**A RESOLUTION AUTHORIZING THE MAYOR TO SIGN  
CHANGE ORDER NO. 2 WITH WILSON BROTHERS CONSTRUCTION  
FOR THE WATER TREATMENT PLANT INTAKE PROJECT  
CONSTITUTING AN INCREASE OF \$205,850.00.**

Date of Issuance: September 6, 2016	Effective Date: September 6, 2016
Owner: City of Laurel, Montana	Owner's Contract No.: FEMA: 1996-DR-MT-PW 01679 SRF: EQ 16-1684
Contractor: Wilson Bros. Construction, Inc.	Contractor's Project No.: N/A
Engineer: Great West Engineering, Inc.	Engineer's Project No.: 2-07128-TO26
Project: Water Treatment Plant Intake	Contract Name: N/A

**Schedule of Work Items for Change Order No. 2: Intake Pump Bypass**

**CITY OF LAUREL, MONTANA**  
**WATER TREATMENT PLANT INTAKE**  
 INTAKE TRANSMISSION MAIN #1 PLAN & PROFILE  
 STA 180+00 TO STA 190+00

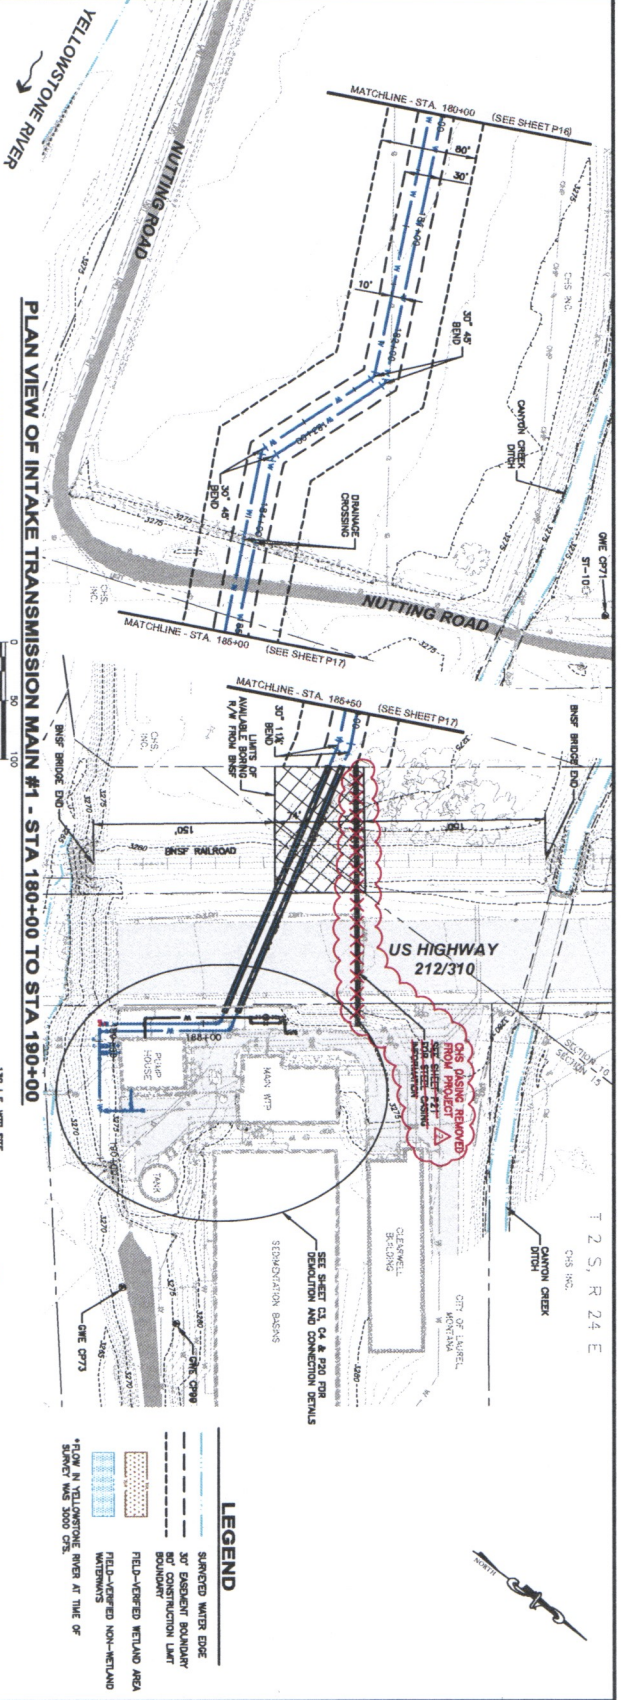
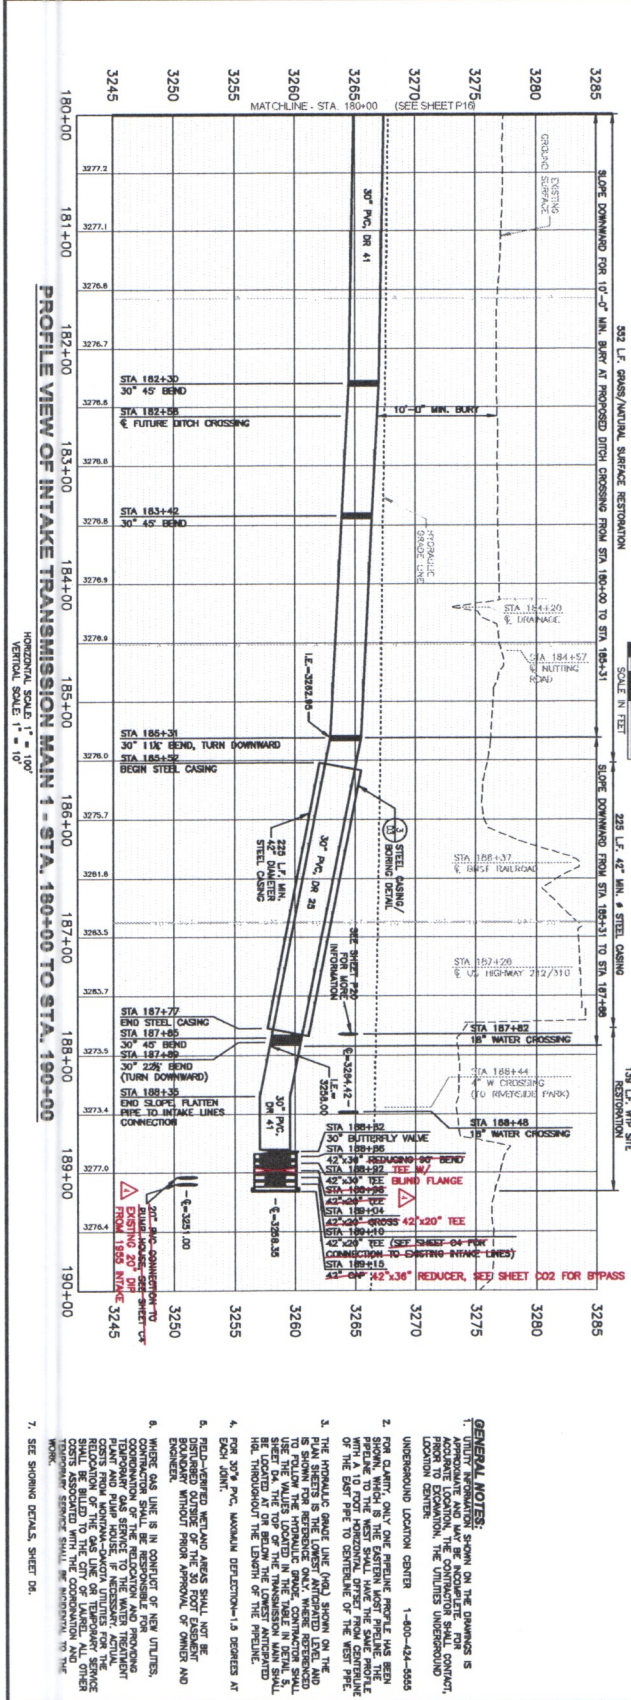
NO.	REVISION DESCRIPTION	BY	DATE	SET NO.
▲	ADDENDUM NO. 1 BEDDING AND AIR RELEASE VAULT REVISIONS	LMW	5-20-16	
▲	ADDENDUM NO. 2 MISCELLANEOUS REVISIONS	LMW	6-2-16	
▲	CHANGE ORDER NO. 1: CONTROL BUILDING RELOCATION	LMW	6-29-16	
▲	CHANGE ORDER NO. 2: WTP BYPASS LINE CLARIFICATIONS SHEET #17	LMW	7-31-16	
▲				
▲

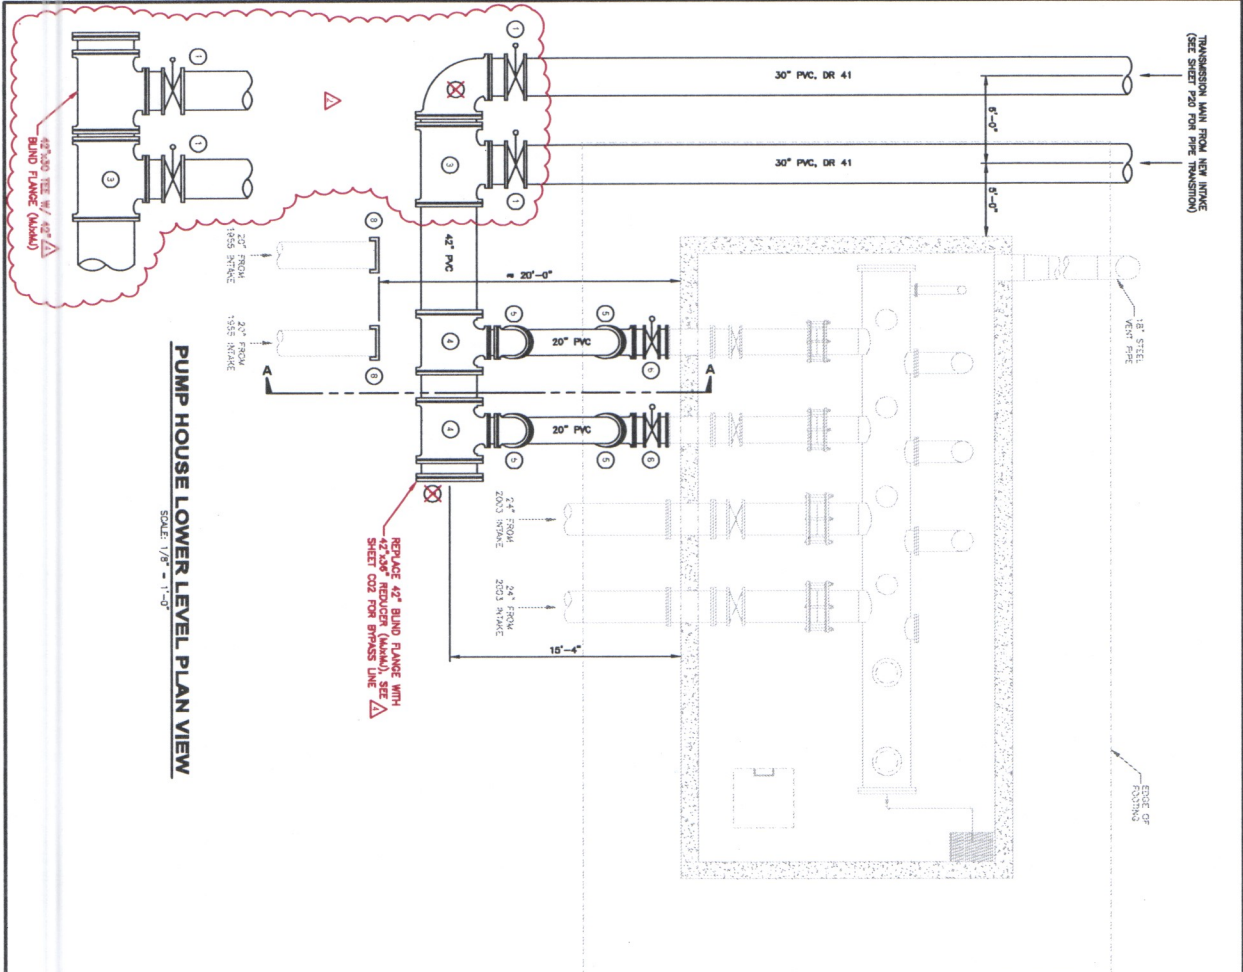
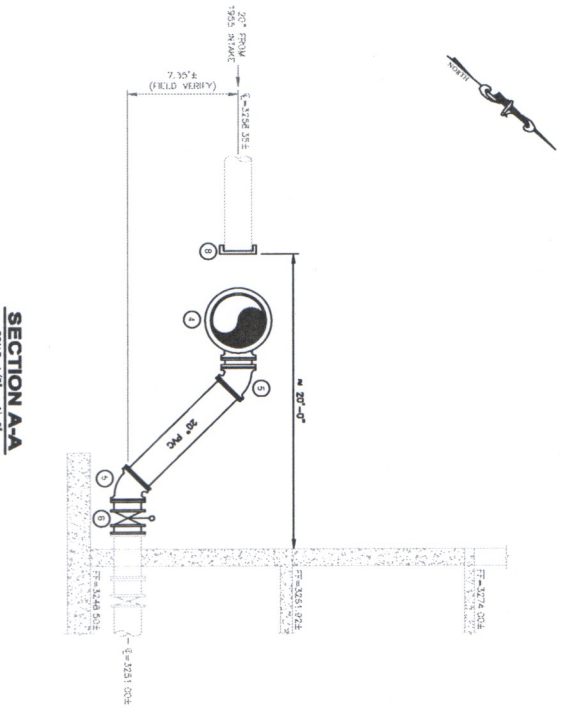
This Change Order is for work associated with the installation of a gravity bypass for raw water coming from the new intake. The bypass will allow raw water enter the flocculation basins without passing through the existing raw water pumps. The work is further described on the attached Schedule of Work Items and Construction Plans, as listed.

**CITY OF LAUREL, MONTANA**  
**WATER TREATMENT PLANT INTAKE**  
WTP BYPASS LINE ALIGNMENT PLAN & PROFILE  
STA 10+00 TO STA 15+00

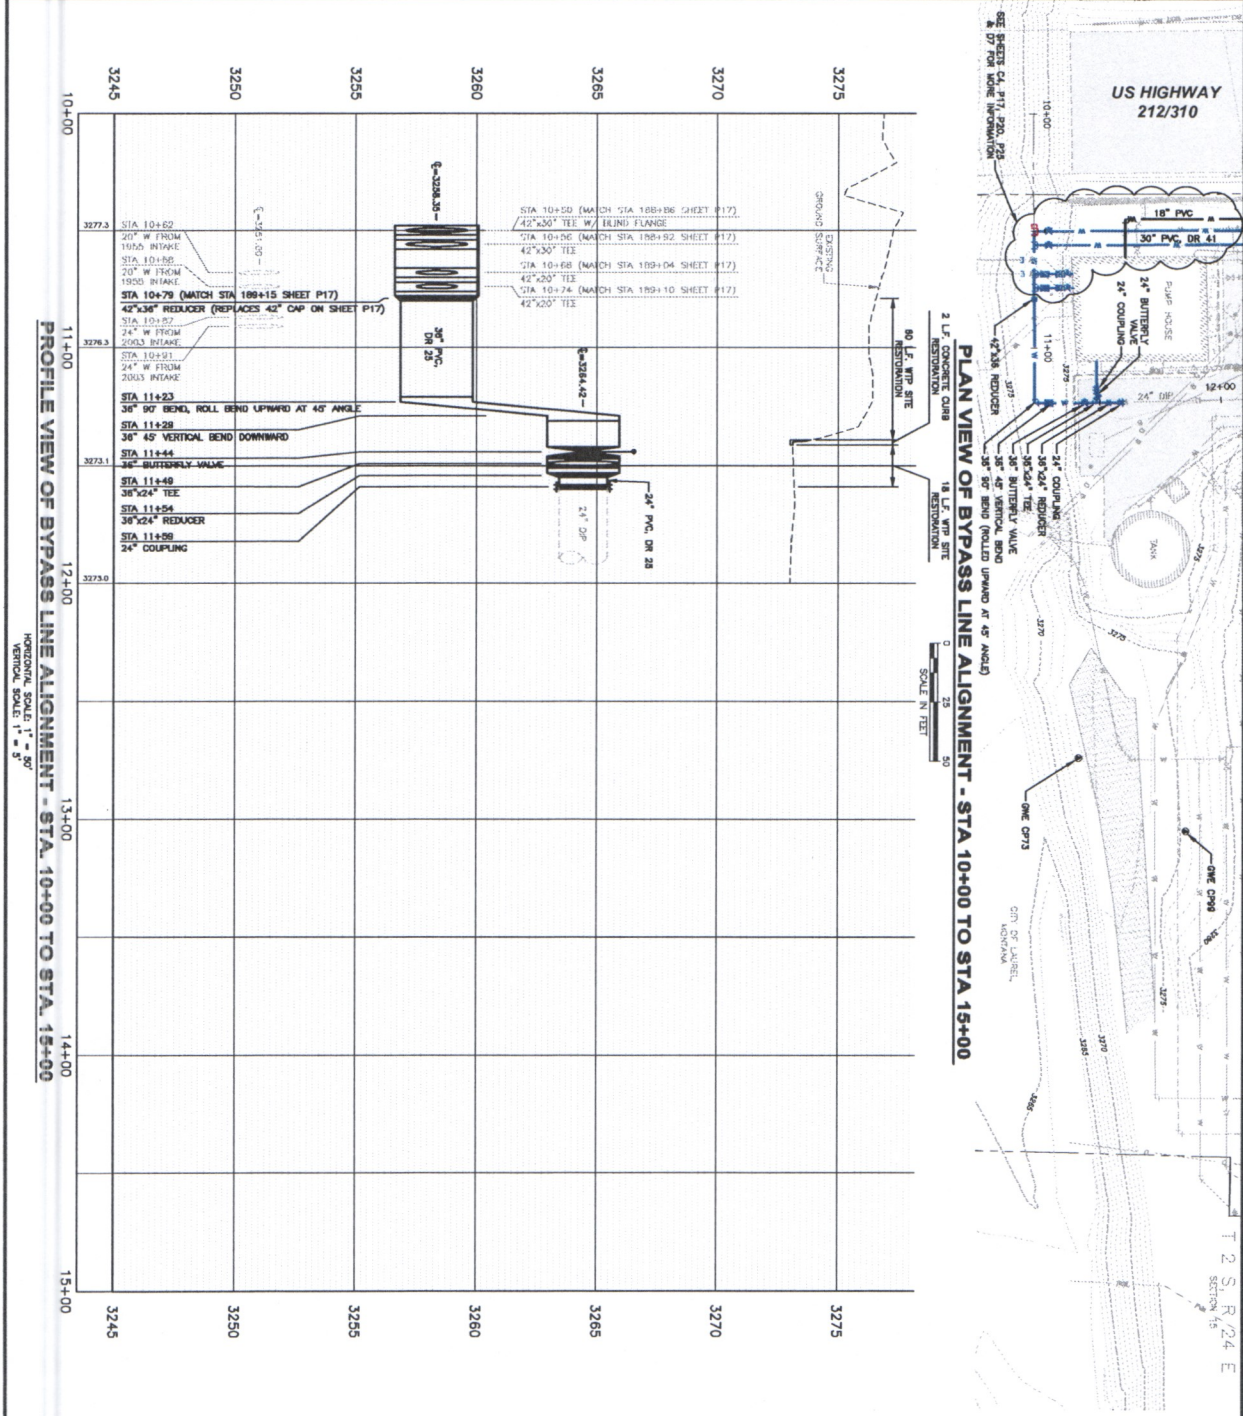
**ALL WORK THIS SHEET  
CHANGE ORDER NO. 2**

LAUREL INTAKE AND PUMP STATION  
LAUREL, MONTANA  
PUMP STATION AND PIPING GALLERY PLAN VIEWS

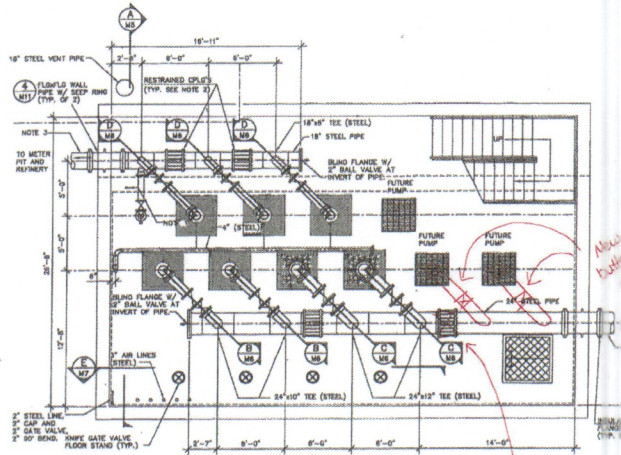
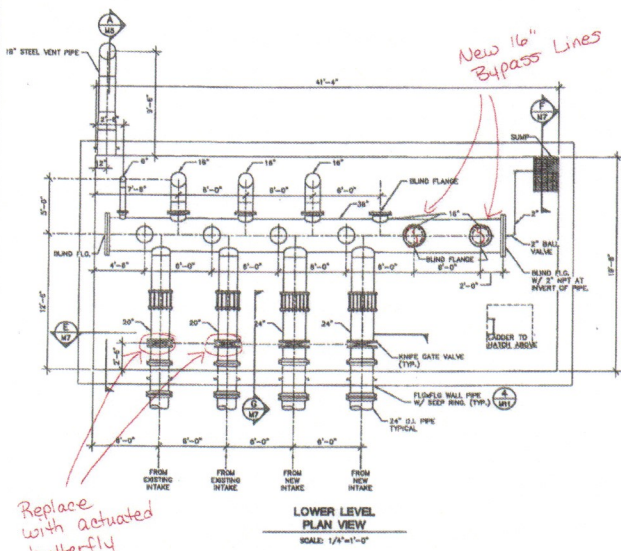
Option C would provide pressure reduction on the intake lines, bypass the intake pumps inside the building utilizing the existing stubs for new pumps, and flow directly to the Parshall flume (or pre-sedimentation basins once the WTP construction is complete).

*New 24" Butterfly Valve*

*New 24" Butterfly Valve*

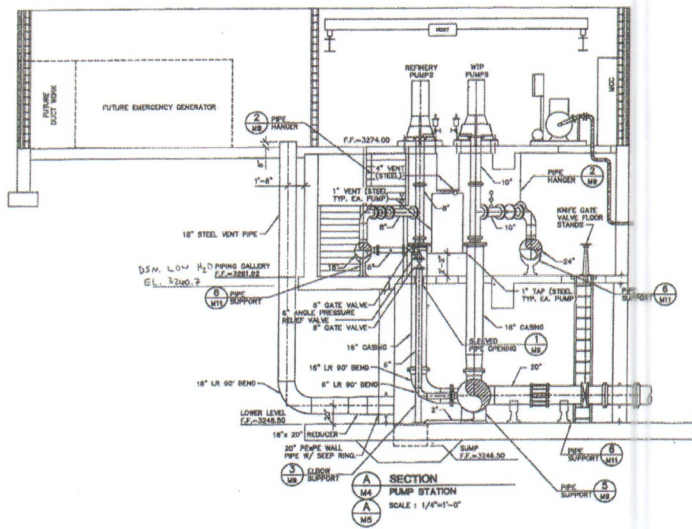
Replace with actuated butterfly valves

New 16\"/>
